Planning Commission Staff Report

Meeting Date: September 23, 2019

Petition: **P.Z. 04-2019 13559 Olive Blvd (McDonald's)**: A request for a zoning map amendment from a "C8" Planned Commercial District to a "PC" Planned Commercial District for a .86 tract of land located north of Olive Blvd., west of its intersection with North Woods Mill Rd. (16Q241471)

PDP-1
PRELIMINARY DEVELOPMENT PLAN
FG JOB NO 0180691.00

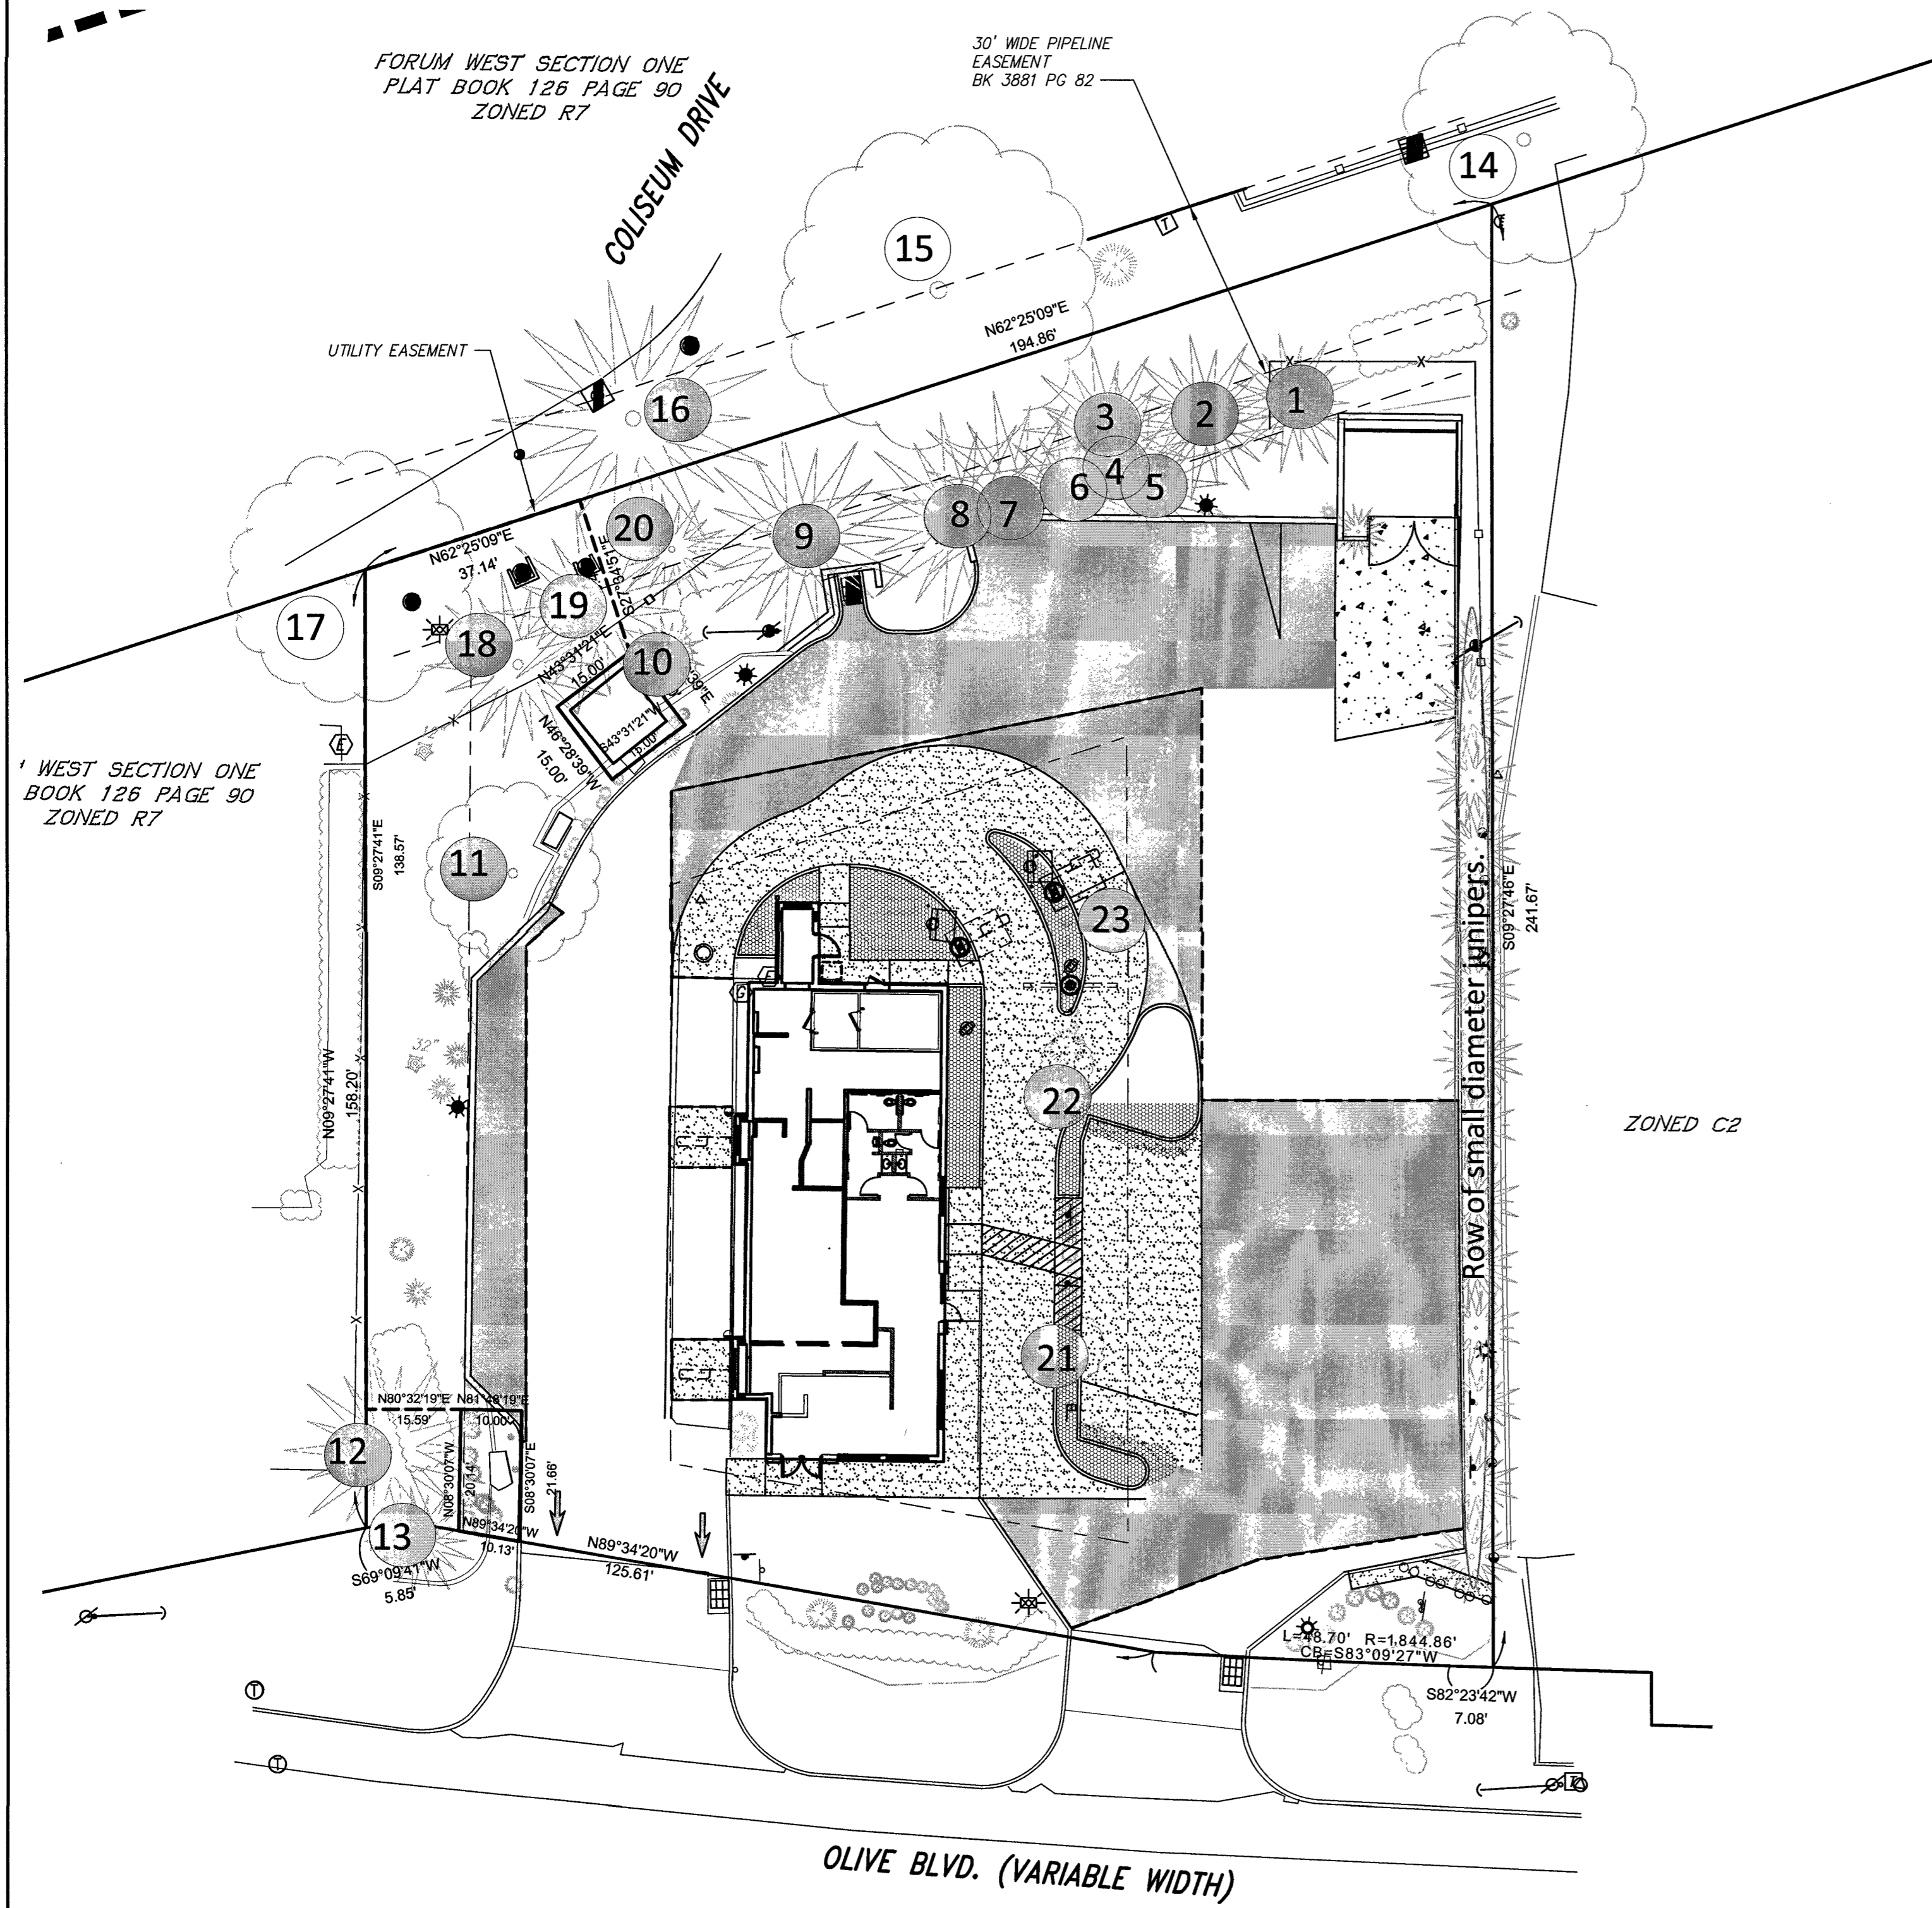
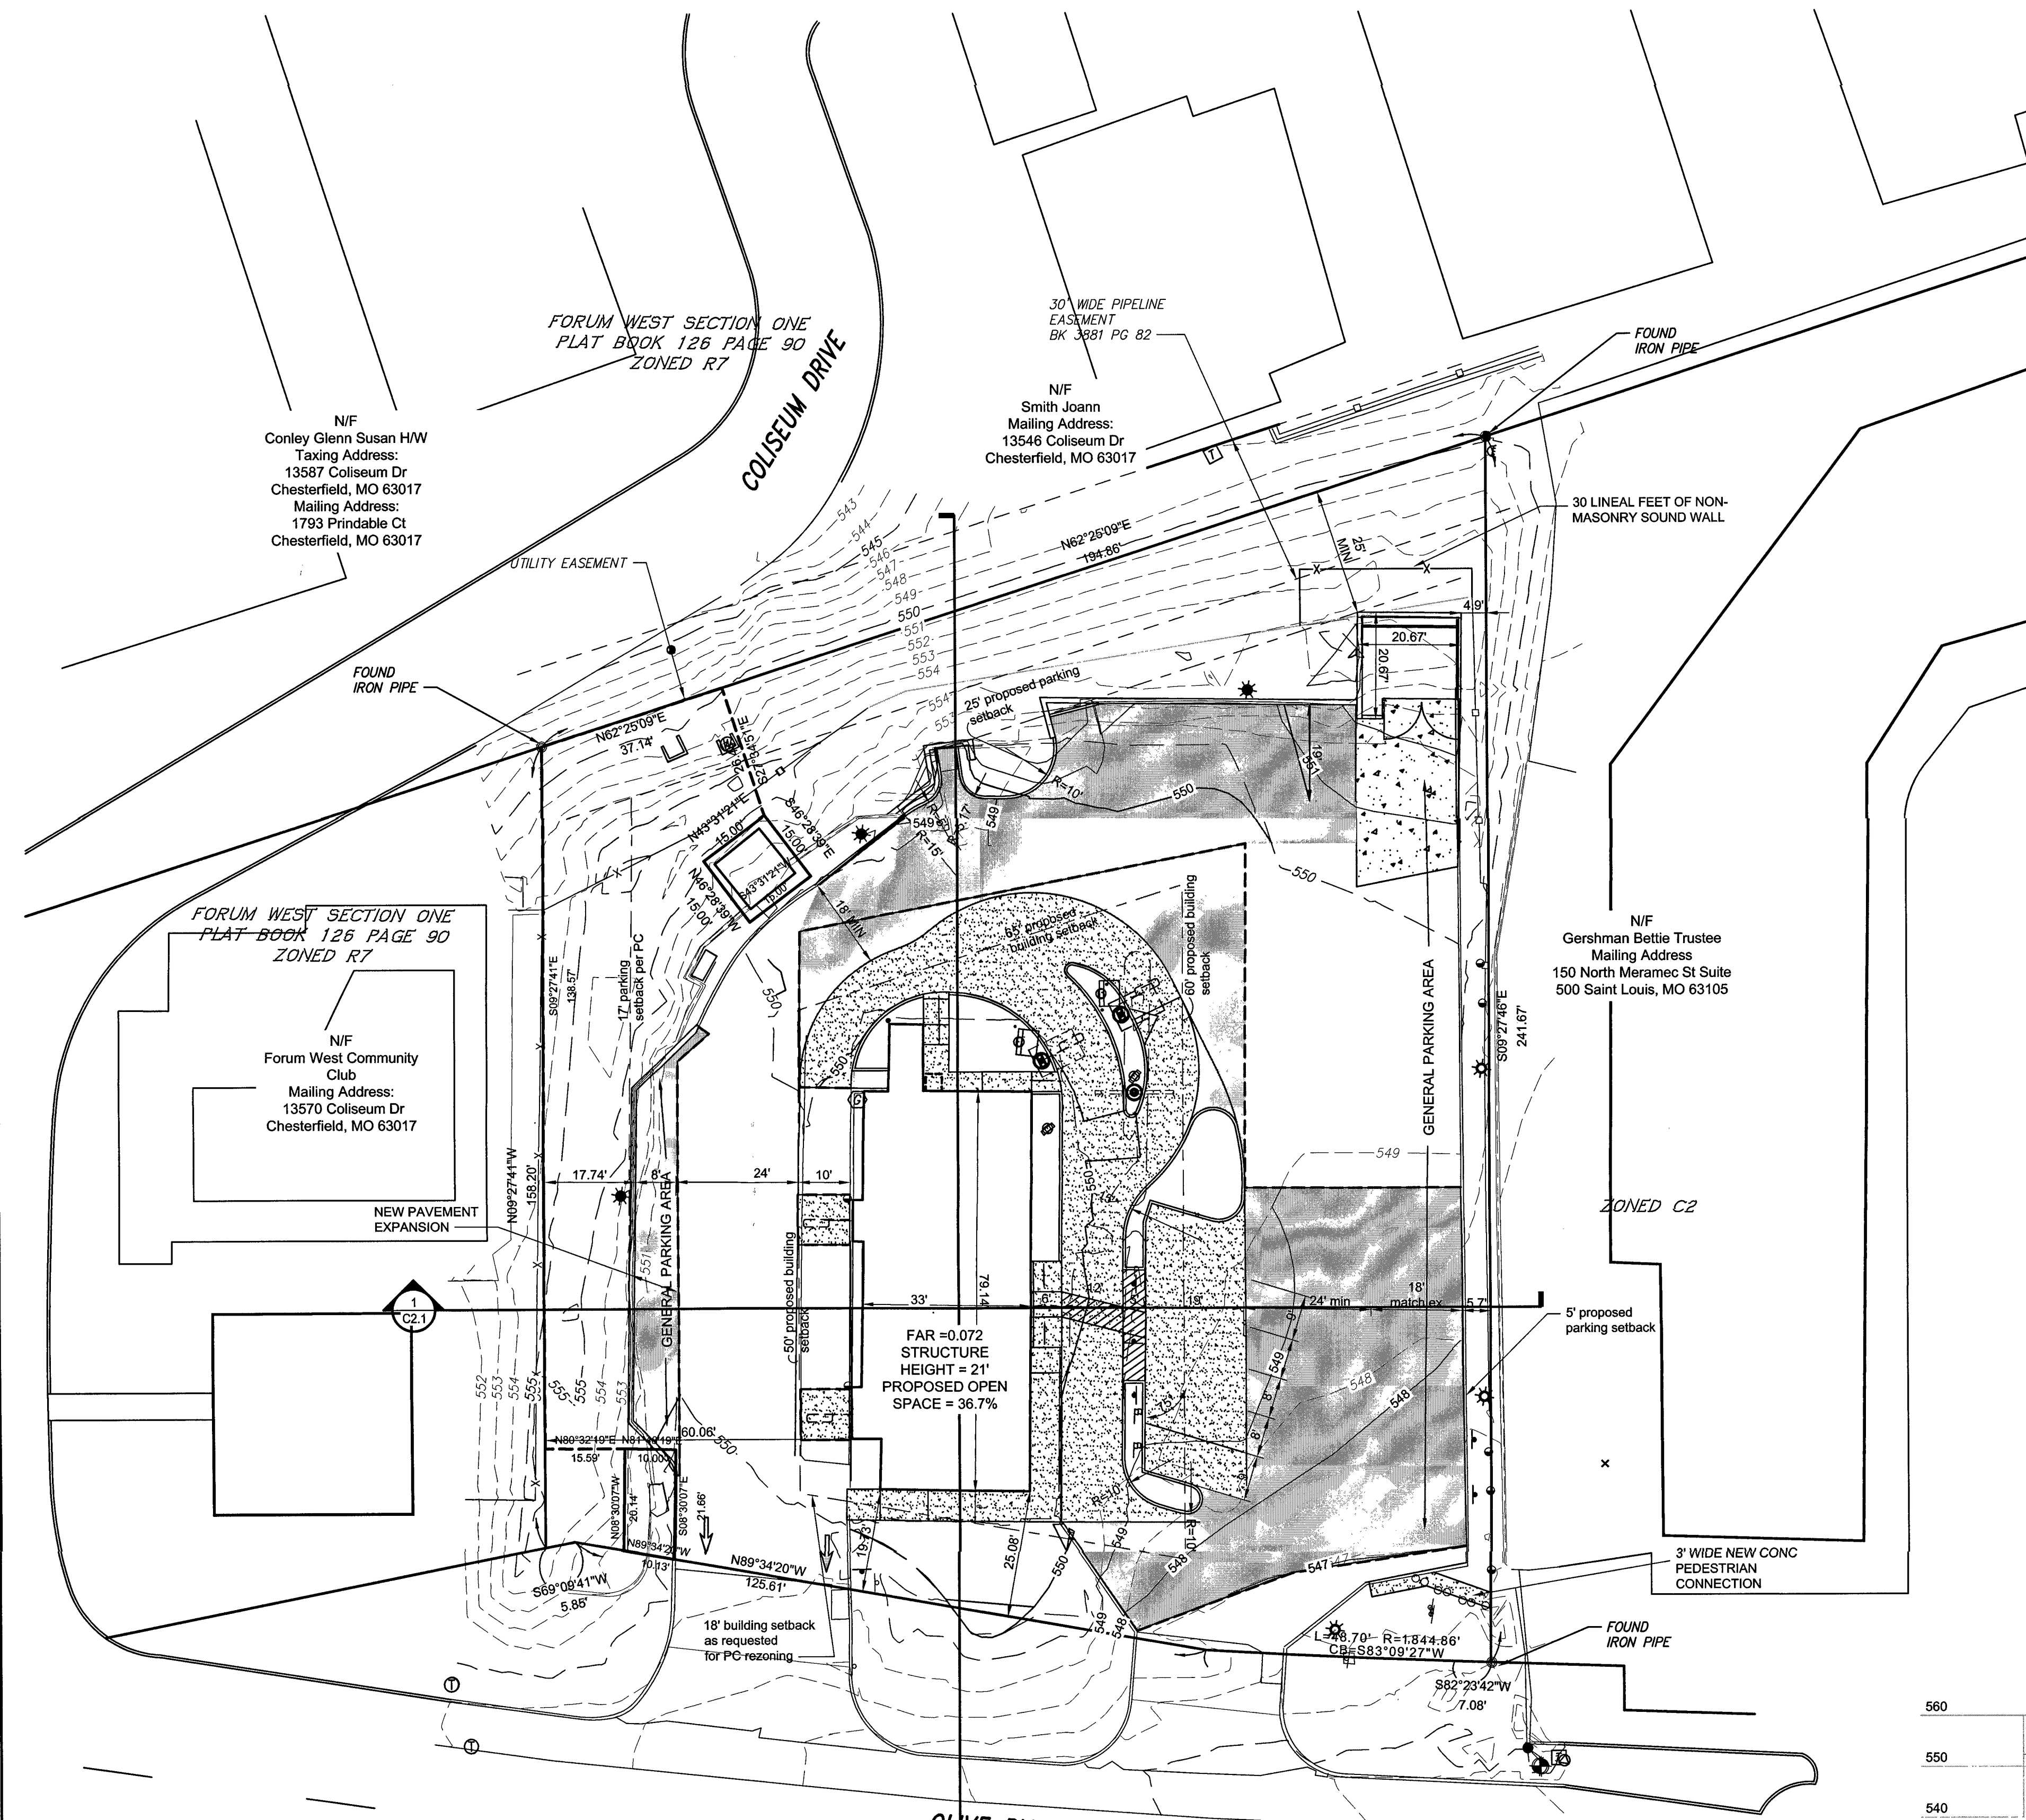
2. **Access / Cross-Access**- Concerns were brought forward with the subject site in regard to both vehicular site circulation and pedestrian site circulation.
 - It was stated at the Public Hearing that the ideal vehicular cross-access would be with the commercial development to the east of the site. The applicant at that time mentioned that establishing a cross-access easement would allow for the ideal vehicular cross-access if the site to the east were to re-develop. Provide confirmation that a cross access easement will be dedicated to the property to the east to allow for future vehicular and pedestrian cross access. The location of the cross access easement shall be as recommended by the Developer's Traffic Engineer and shown on the Amended Site Development Plan. This cross-access easement must be secured prior to Improvement Plan approval.

- The construction of a sidewalk along Olive Blvd was an issue raised by the Planning Commission, is a Unified Development Code requirement, and a Comprehensive Plan Policy. Identify the location of this sidewalk on the Preliminary Development Plan.

4. **Trash Location-** The Preliminary Development Plan depicts the trash enclosure positioned north from its current location and, as a result, closer to the residential property to the north.
 - Identify how the updated trash location will impact residents to the north.

Response – The applicant stated that the client is agreeable to recording an agreed upon cross-access easement between the McDonald's parcel and the shopping center parcel to the east, with the understanding that no physical pavement connection would be built at this time, but at the time of a possible re-development of the shopping center.

In regards to the sidewalk along Olive Blvd, MoDOT has communicated that they have a planned project for future improvements along Olive Blvd that includes a sidewalk. The location of the sidewalk immediately adjoins the back of curb and will comply with ADA guidelines. MoDOT has provided confirmation to City Staff that the improvements are budgeted for 2021. The applicant did state that they are agreeable to providing a short connection of sidewalk approximately 25 ft long connecting the McDonald's site to the shopping center to the east, which is depicted on the Preliminary Development Plan.

Response – The applicant stated that the trash pick-up is 6 days a week (Sunday excluded). The new location of the trash enclosure will necessitate the existing screening fence be removed. To mitigate the impact of the new location, the applicant is agreeable to re-installing a new denser (non-masonry) screening fence on the north side of the new trash enclosure for an approximate length of 30 feet as depicted on the submitted Preliminary Development Plan.
